TOWN OF UNDERHILL

Development Review Board

TIMOTHY & THERESA POTVIN
SKETCH PLAN REVIEW
Docket #: DRB-20-01

Project Proposal: Sketch Plan Review of Timothy & Theresa Potvin for a proposed 2-Lot Subdivision of property located at the aforementioned address.

SECTION 3.17 – SOURCE PROTECTION AREAS

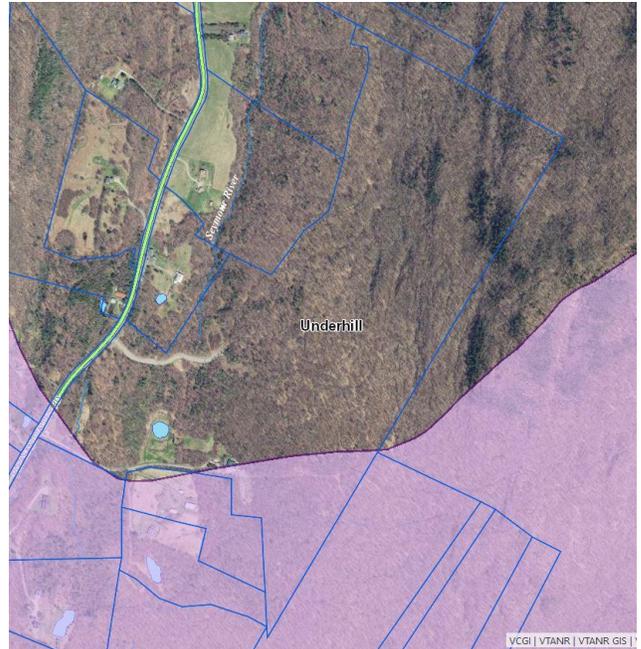
- Both proposed lots will contains areas designated as a Groundwater Source Protection Area; however, since the development already exists, and no new development is being proposed as a direct result of this subdivision application, review under this section is not required.

SECTION 3.18 – STEEP SLOPES

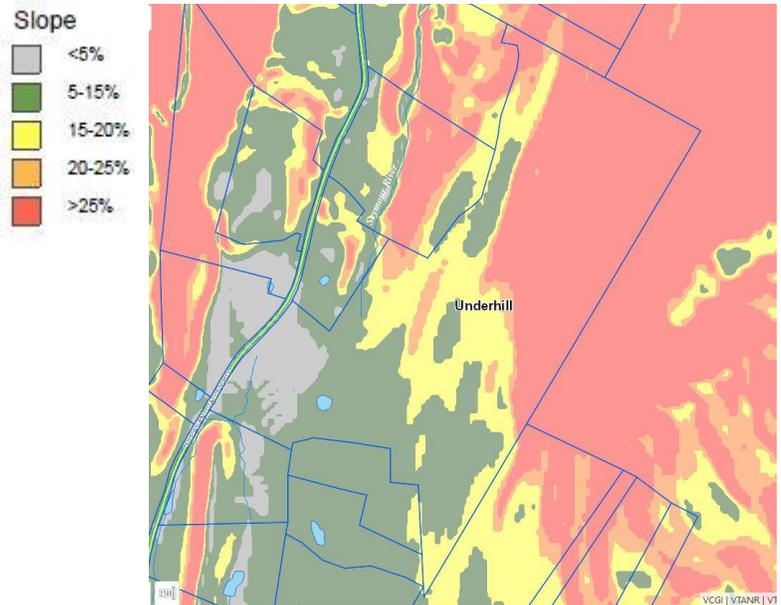
- Areas of steep slopes (15-25%) are present on the existing lot – 145 Moose Run (see directly to the right).
 - The existing development (the single-family dwelling that will remain on Lot 2 and the accessory dwelling that will remain on Lot 1) appear to be located in areas that do not contain areas of Steep Slopes (15-25%) or very steep slopes.
- Since the development already exists, and no new development is being proposed as a direct result of this subdivision application, review under this section is not required.

SECTION 3.19 – SURFACE WATERS & WETLANDS

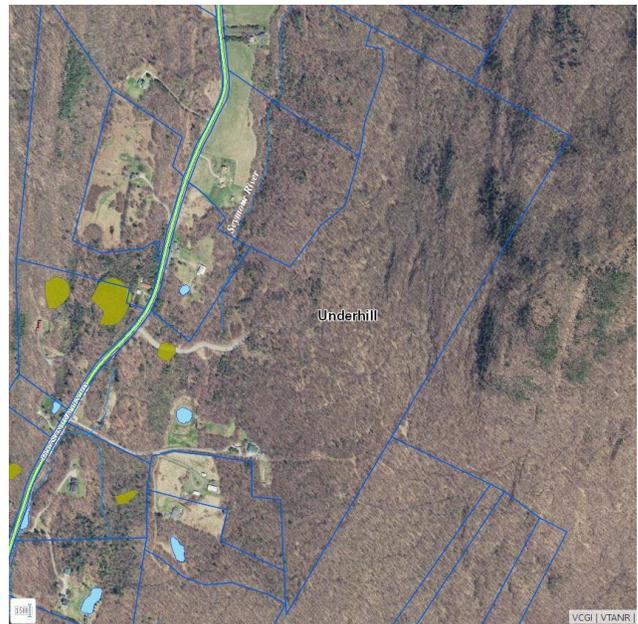
- An unnamed stream will exist on the proposed Lot 1, and should be identified on the engineer plans that will be submitted as part of the preliminary subdivision review application.
- Class II and Class III Wetlands were identified on the engineers plans from when the Applicants previously subdivided land from the subject lot (see Exhibit I) (DRB Docket #: DRB-10-11 – the Lap Run Subdivision).
 - Since wetland delineations are only valid for three to five years, the Applicants should confirm if these Wetlands still exist or if any new wetlands have emerged since the previous subdivision.
- Since the development already exists, and no new development is being proposed as a direct result of this subdivision, additional review is not anticipated under this section.
